# Autoclass reference time v100

The Autoclass measurement time for the PSE (defined by  $T_{\text{AUTO\_PSE1}}$  and  $T_{\text{AUTO\_PSE2}}$ ) and the Autoclass maximum power draw time for the PD (defined by  $T_{\text{AUTO\_PD1}}$  and  $T_{\text{AUTO\_PD2}}$ ) is referenced from two different moments. The reference time for the PSE is “the transition of POWER\_UP to POWER\_ON”, where that for the PD is “measured when  $V_{\text{PD}}$  rises above  $V_{\text{Port\_PD-2P min}}$ ”. The PSEs time reference is not readily observable at the PI. This is unnecessarily complicated.

Figure 145-14—PSE Autoclass state diagram

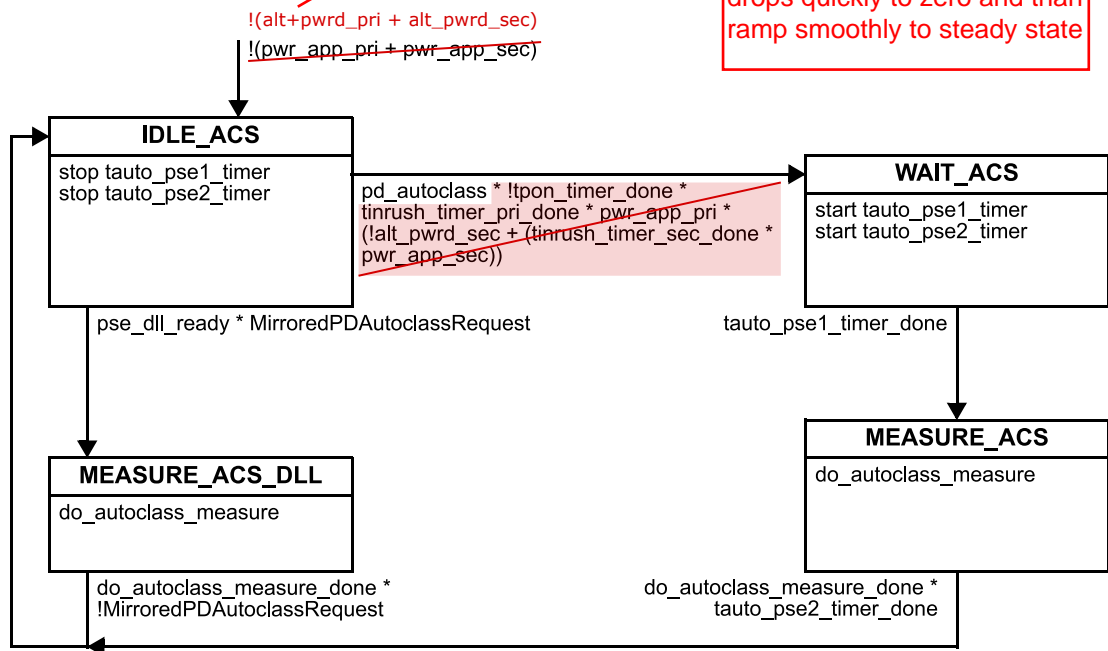
Change Figure 145-14 as follows:

Do you mean the 1st time Vpse or Vpd crosses 30V? (In some compliant PDs The voltage gets to 30V and then drops quickly to zero and then ramp smoothly to steady state)

This baseline proposes to change both reference times to when  $V_{\text{PSE}}$  or  $V_{\text{PD}}$  crosses 30V. Regardless of what inrush scheme is used, this moment occurs near simultaneous for both devices and is observable at the PI. Timings can remain as-is.

Figure 145–26—Single-signature PD Autoclass state diagram

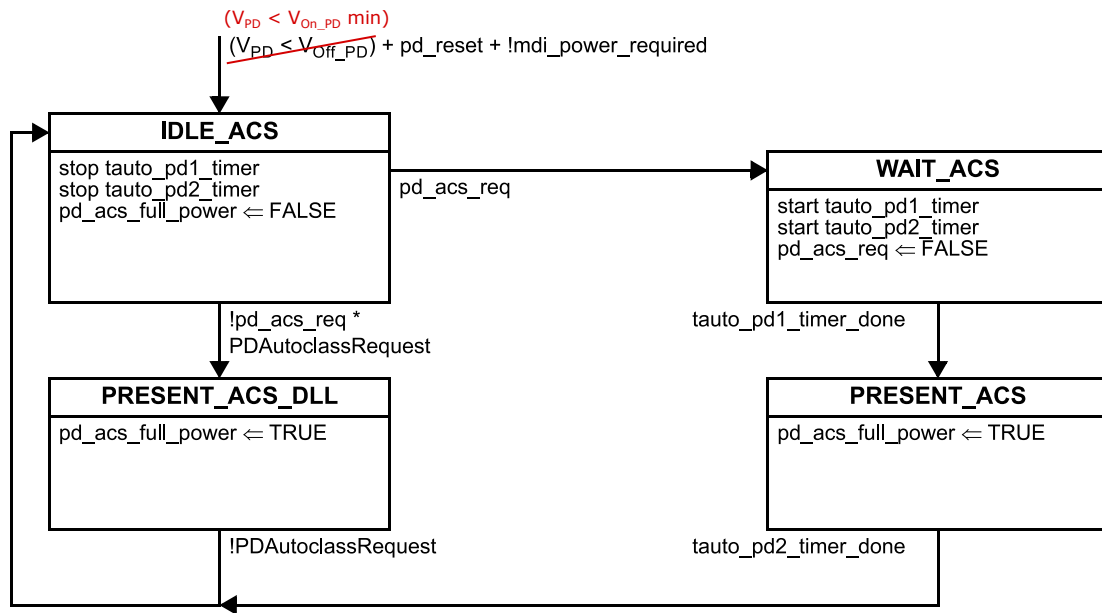
A final issue is that currently the PD state diagram does not agree with the PD Autoclass text. While the text uses  $V_{\text{Port\_PD-2P min}}$  as reference, the state diagram uses  $V_{\text{PD}} > V_{\text{Off\_PD}}$  as the reference point.

Change Figure 145–26 as follows:

After power up, a PD that implements Autoclass shall draw its highest required power,  $P_{\text{Autoclass\_PD}}$ , subject to the requirements on  $P_{\text{Class\_PD}}$  in 145.3.8.2, throughout the period bounded by  $T_{\text{AUTO\_PD1}}$  and  $T_{\text{AUTO\_PD2}}$ , measured from when  $V_{\text{PD}}$  rises above  ~~$V_{\text{Port\_PD-2P min}}$~~   $V_{\text{On\_PD min}}$ .
